AGENDA

LOCAL TRAFFIC COMMITTEE MEETING

MONDAY 18 JULY 2022

ATTACHMENT 1

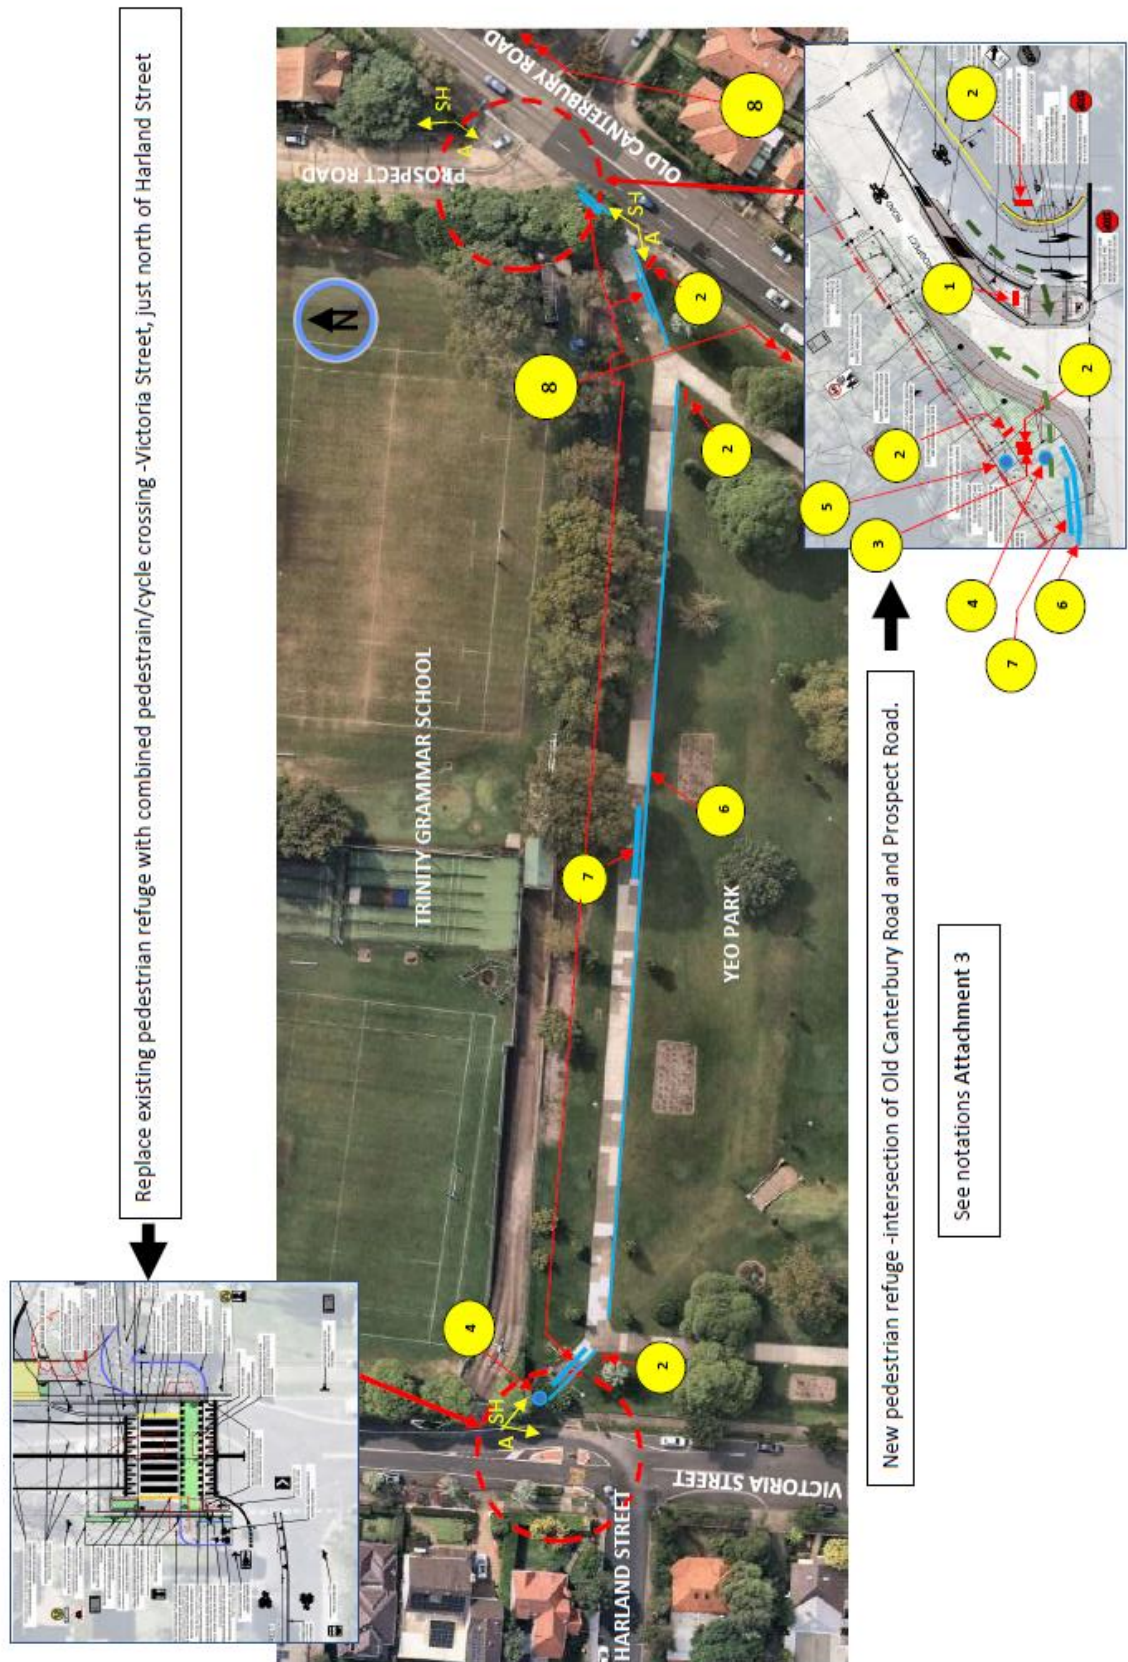
Council Officers tabled an amended sign and line marking plan and notations that were changed to align with Australian Standards (Attachment 1). The main change is to the signage guiding cyclists from the road onto the footpath and the footpath to the roadway.

The TfNSW representative supported the concept plan and requested the detailed signage plan for review and approval. The Committee members agreed to add this request to the recommendation.

1. **the formalised treatment of the (off-road) shared pedestrian-bicycle path through Yeo Park, Summer Hill, with signs and line marking as shown in the amended plan and notations of ATTACHMENTS 2 and 3, be APPROVED; and,**
2. **the detailed design plan be submitted to TfNSW for their review and approval.**

ATTACHMENT 3 – PROPOSED AMENDMENT TO TRAFFIC AND PARKING CHANGES IN MURRELL STREET, ASHFIELD

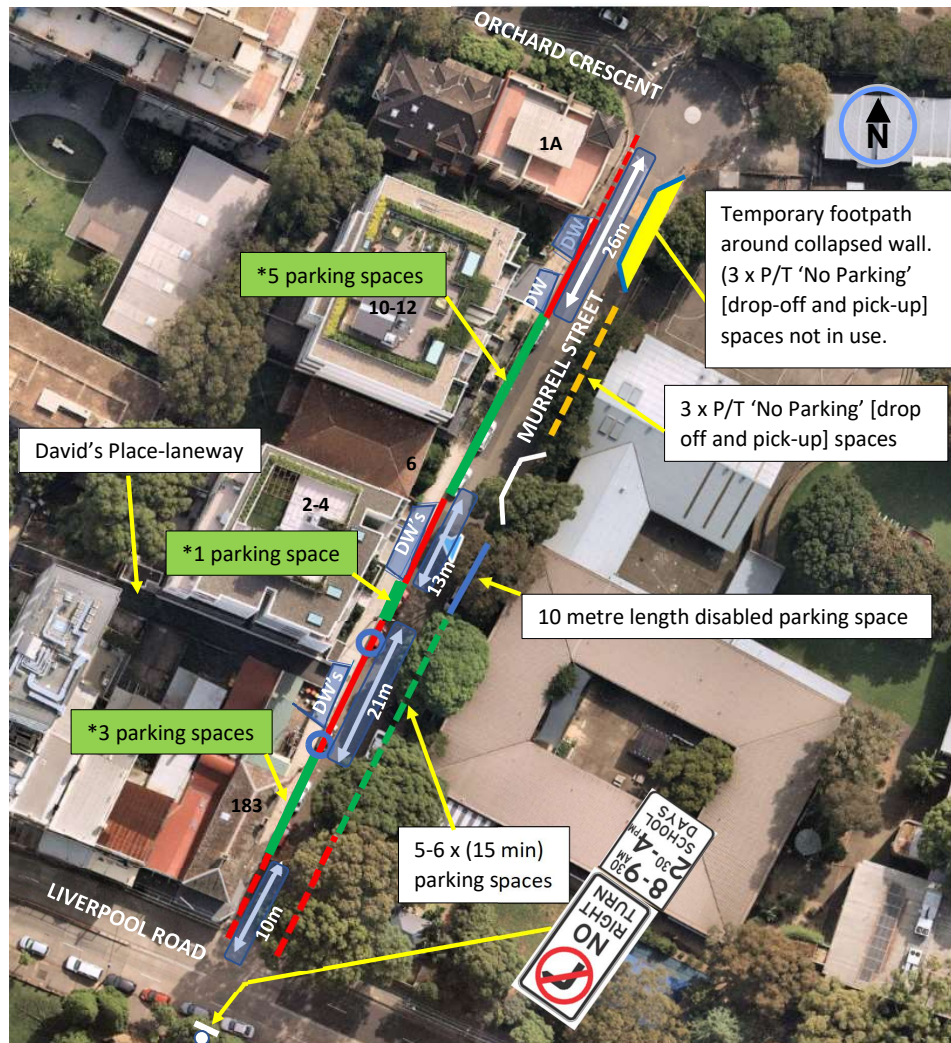
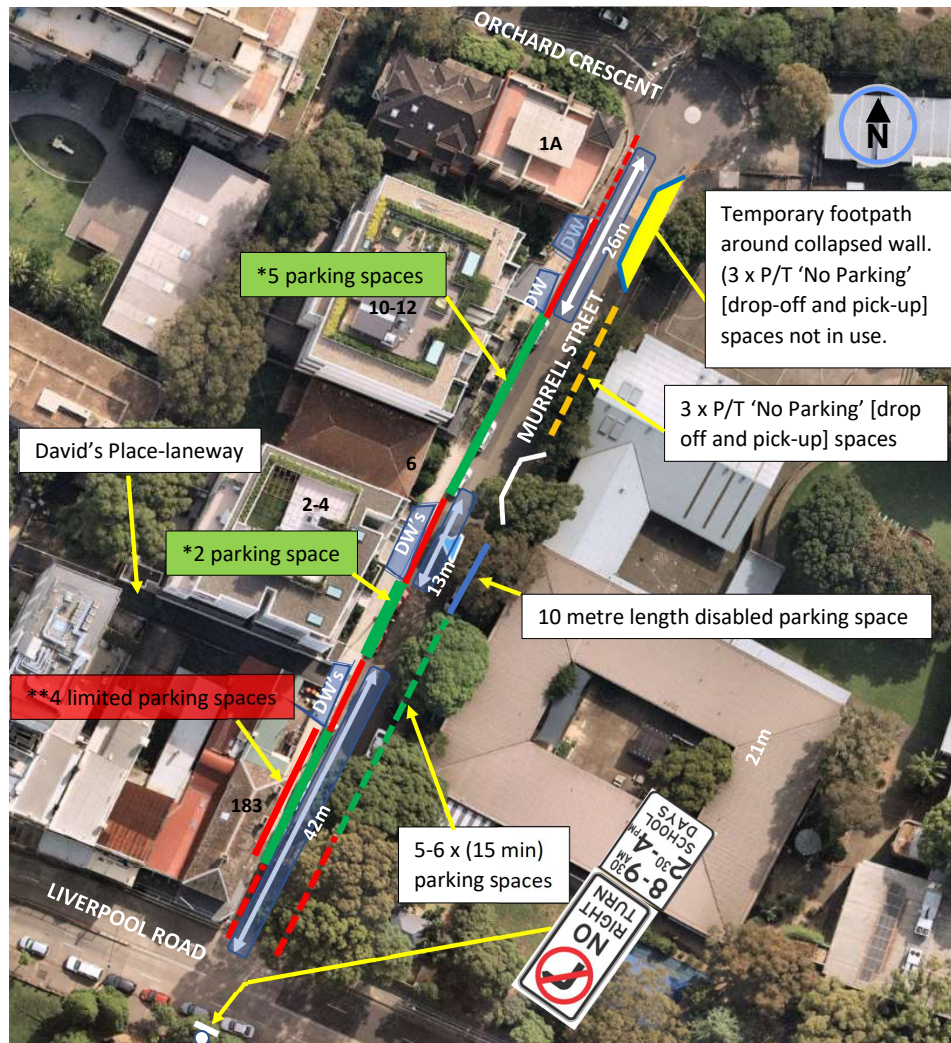
**ATTACHMENT 2 – INITIAL PROPOSAL TO TRAFFIC AND PARKING CHANGES
IN MURRELL STREET, ASHFIELD**
